STATE OF WISCONSIN

Department of Safety and Professional Services
1400 E Washington Ave.
Madison WI 53703

Frequently Asked Questions/UDC Wall Bracing Emergency Rules. Effective date of Emergency Rules April 1, 2014

Figure 321.25-B
DEFINING BUILDING SIDES AND LENGTHS WITH ONE OR MORE CIRCUMSCRIBED RECTANGLES^{a,b,c}

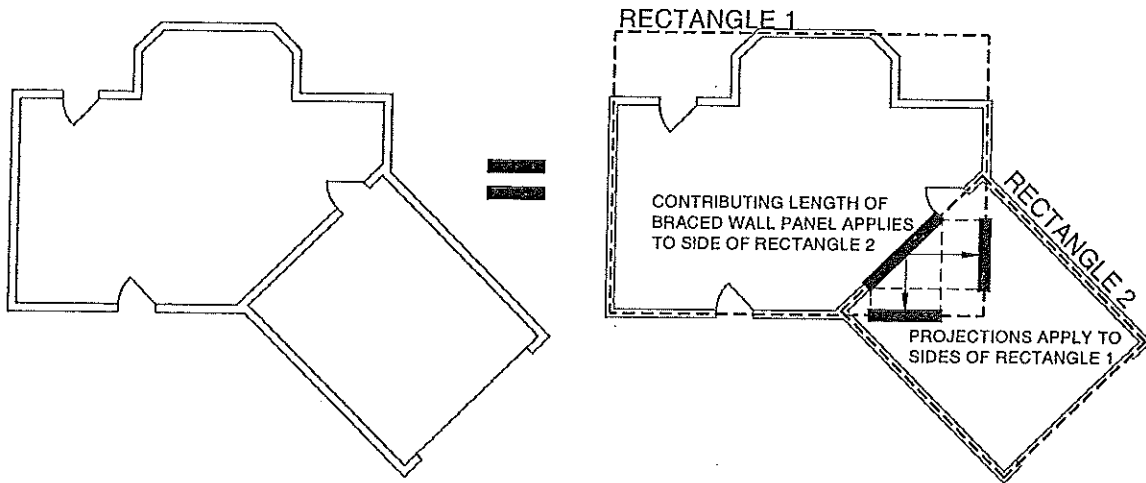
17. Figure 321.25-B footnote 'b'. Can you define what is meant by enclosed plan offsets and projections? Is a screen porch classified or defined as enclosed?

18. Figure 321.25-B, Do rectangles have to abut at a wall line? Can it be a 100% interior wall line? How do you draw rectangles for homes with segments constructed at an angle or an attached garage at an angle to the dwelling?

There are definitions currently in the UDC that provide guidance on this topic. SPS 320.07(59m) definition of a "Porch" means an unenclosed exterior structure at or near grade attached or adjacent to the exterior wall of any building, and having a roof and floor.

SPS 320.07(10t) definition of a "Carport" means a structure used for storing motorized vehicles that is attached to a dwelling and has at least 2 sides completely unenclosed.

Carports are specifically exempted as are open structures such as decks. A deck is a porch without a roof. A screen porch with no enclosing walls of any height and no other construction other than the structural members necessary to support the roof and the screen itself will be considered an open structure that can be excluded from the rectangle.

Generally speaking, yes you want adjacent rectangles to abut at a common wall line which will be at least partially an interior wall line. It is permissible for rectangles to overlap but this will result in more bracing being required than if the rectangles did not overlap.

For guidance on drawing rectangles for homes with angled segments or attached garages at an angle to the dwelling see the added diagrams in the proposed permanent rule package which also provide a method for calculating the amount of bracing which can be attributed to an angled wall segment.

**FIGURE 321.25-C
LOCATION OF BRACED WALL PANELS ALONG A BUILDING SIDE^a**

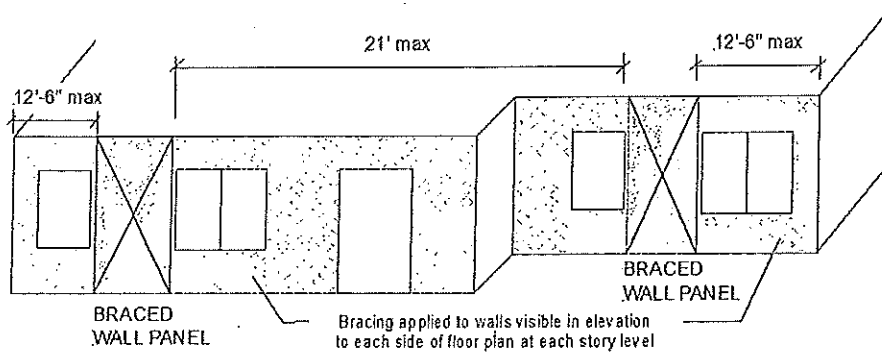
- 25. Figure 321.25-C Where does the 21-foot spacing begin and end with a portal frame?**

Per Figure 321.25-A a portal frame whether consisting of one or two narrow panels has a maximum opening dimension of 18’ and therefore will automatically comply with the 21’ spacing requirement. If only one side of the opening has a narrow panel the opposite side is required to be either a wood structural panel (WSP) if using the intermittent method or a continuously sheathed wood structural panel (CS-WSP) if using the continuous method. Then, at the outer extent of the portal frame figure whether it is a narrow panel or standard braced wall panel you measure the 21’ away from portal frame from the outside edge of the panel in the figure to the outside edge of the next nearest panel.
